### Service Bulletin

**Title:** SB 407-060120; Bell 407 Air Conditioning System Aft Firewall Retrofit

**Applicability:** Bell Helicopter Textron, Inc (Bell) Model 407 helicopters equipped with the Air Comm Corporation 407EC-203-2 air conditioning system with the Bell Technical Bulletin 407-19-130 applied

**Reference:** FAA / STC # SR00222DE, Bell 407 Air Conditioning System.

**Figure 1: Belt Guard Installation**

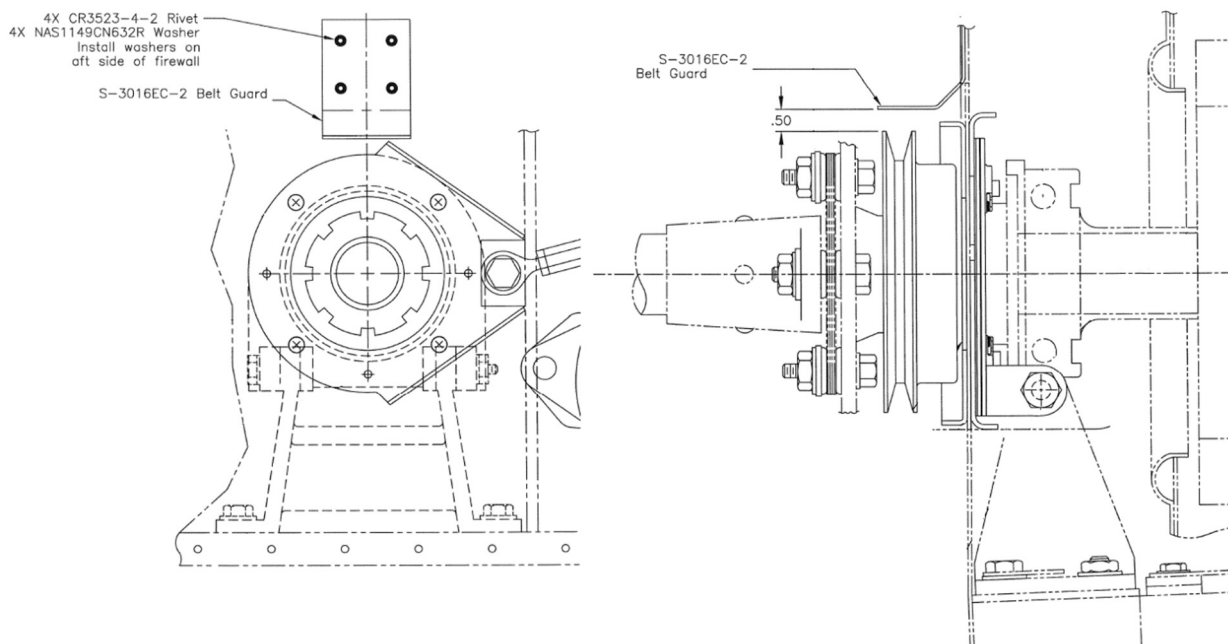
1. Install the S-3013EC-101 and S-3013EC-102 Stiffeners to the firewall using 18x CR3523-4-2 rivets as shown in Figure 3.
2. **NOTE:** The oil cooler blower shaft may be optionally removed to facilitate installation of the S-3013EC-101 and S-3013EC-102 Stiffeners. If removed, reinstall oil cooler blower shaft after completion of this Service Bulletin and align per 407-MM DMC-407-A-65-10-00-01A-720A-A using Tool Kit T103388.
3. Install the S-3016EC-2 Belt Guard to the firewall using 4x CR3523-4-2 rivets and 4x NAS1149CN632R washers as shown in Figure 1.

**Figure 2: Safety Strap Installation (view looking inboard from LH side)**

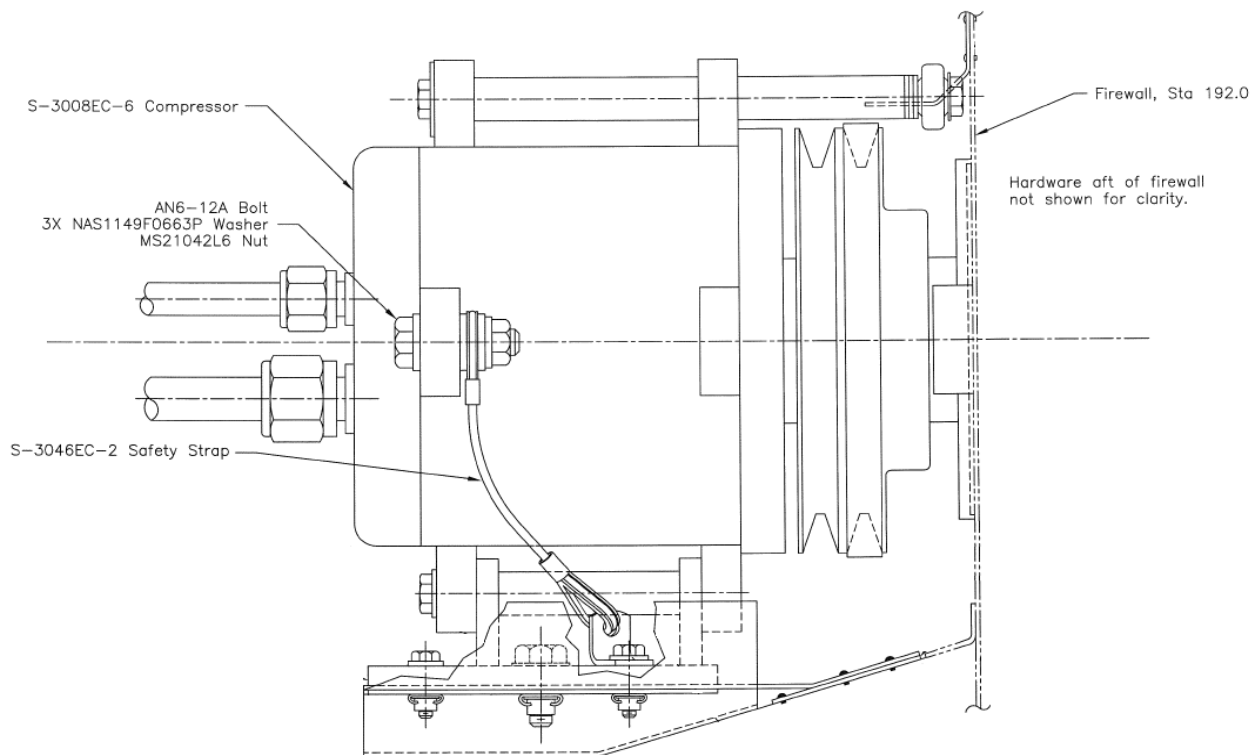
4. Match drill rivet and bolt holes for 7x MS21059L3 nutplates thru firewall and stiffeners, using the existing S-3010EC-8 collar as a template. See Figure 3 for match drill locations.
5. Install 3x MS21059L3 nutplates to the stiffeners and firewall using 2x CCR264CS-3-03 rivets as shown in Figure 3. Install all fasteners with wet coating of MIL-S-38249 Sealant.
6. Re-install the existing S-3010EC-8 Forward Belt Tension Collar and S-3010EC-7 Aft Collar Assembly with 7x MS24694-S52 screws. Install all fasteners with wet coating of MIL-S-38249 Sealant. See Figure 3 for further installation instructions.
7. Install the S-3046EC-2 Safety Strap using an AN6-12A bolt, 3x NAS1149F0663P washers, and MS21042L6 nut, and the existing AN3-6A bolt and NAS1149F0363P washer as shown in Figure 2.
